Responses to the interactive comment on “Validation of the dynamic wake meandering model with respect to loads and power production” by Inga Reinwardt et al., manuscript number: wes-2020-126

Responses to Anonymous Referee #1

Figure A1. Schematic illustration of the flapwise blade root bending moment according to Reinwardt (2017). The aerodynamic force $F_{r,z}$, the gravitational force $F_{g,z}$ as well as the total force F_z perpendicular to the rotor plane at different wake situations are marked.

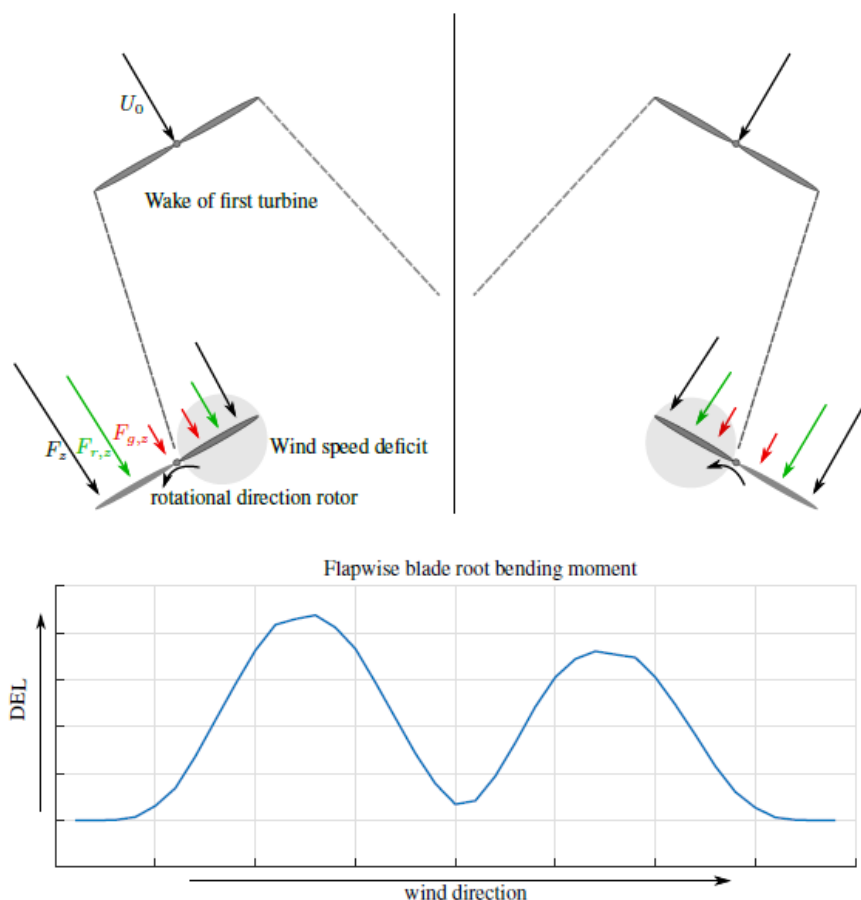
L 297-298: *“Because of the tilt, the blade faces slightly away from the wind direction during the upward movement ... whereas during the downward movement, the blade faces slightly more towards the wind direction”* Not clear to me. Could you clarify, please?

Response: To provide a better explanation of the phenomenon, the following graphical illustration was added to the appendix of the paper.

The explanation of the different pronounced maxima is related to the aerodynamic force and the rotor tilt. The aerodynamic forces on a blade segment are a function of the apparent wind velocity, which is a vector composed of the motion of the blade and the incoming wind. Due to the turbine tilt, the apparent wind velocity is slightly lower during the upward movement, and the aerodynamic force is reduced. The blade faces slightly away from the wind direction during the upward movement, whereas during the downward movement, the blade faces slightly more towards the wind direction, which results in an increase of the aerodynamic force. The aerodynamic force (the green arrow) is higher outside the wake on the left side of the figure than the aerodynamic force on the right side of the figure outside the wake. Similarly, the aerodynamic force in the wake is higher on the right side. At wake conditions, the increase is stronger when the wind speed deficit coincides with the upward movement of the rotor (left side of the figure), so that a higher alternating load at the blade occurs and the maximum is more pronounced in comparison to the case, where the wind speed coincides with the downwind movement of the rotor (right side of the figure).

Figure A2. Schematic illustration of the edgewise blade root bending moment according to Reinwardt (2017). The aerodynamic force $F_{r,y}$, the gravitational force $F_{g,y}$ as well as the total force F_y in the rotor plane at different wake situations are marked.

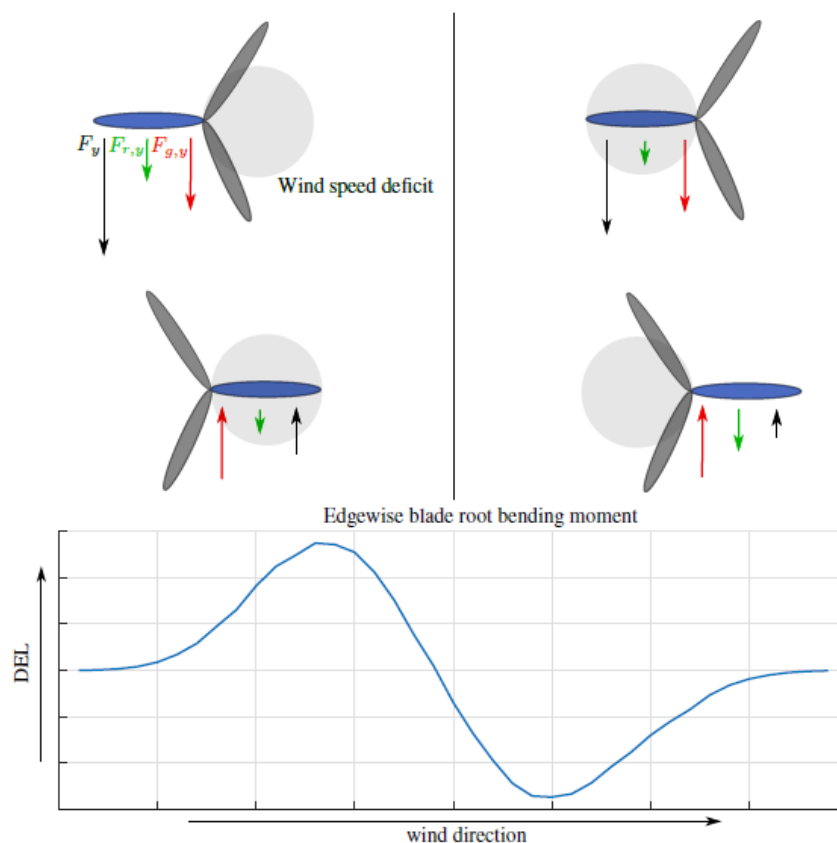
L 311-314: *“The load is defined in the rotating frame of reference, so that the weight force switches its sign with each rotation, whereas the influence of the aerodynamic force on the edgewise moment does not change the sign. Thus, at one side of the rotor the forces level each other out, while on the other side of the rotor they accumulate.”*
 The understanding would be eased if you could add a schematic.

Response: To provide a better explanation of the phenomenon, the following graphical illustration of the edgewise moment was added to the appendix of the paper.

The explanation of the curve of the edgewise moment over the wind direction in wake conditions is also related to the influence of the aerodynamic force, which has an influence on the edgewise moment due to the tilt of the rotor and the gravitational force. The edgewise load is defined in the rotating frame of reference, so that the weight force switches its sign with each rotation (see direction of red arrows in the figure inside and outside of the wake), whereas the influence of the aerodynamic force on the edgewise moment does not change the sign (green arrows). Thus, at one side of the rotor the forces level each other out, while on the other side of the rotor they accumulate. If the deficit is on the side where the forces level each other out, the alternating load increases in comparison to a situation without wake, whereas when the wind speed deficit is on the side where both aerodynamic and weight force are facing in the same direction, the alternating load is decreased.
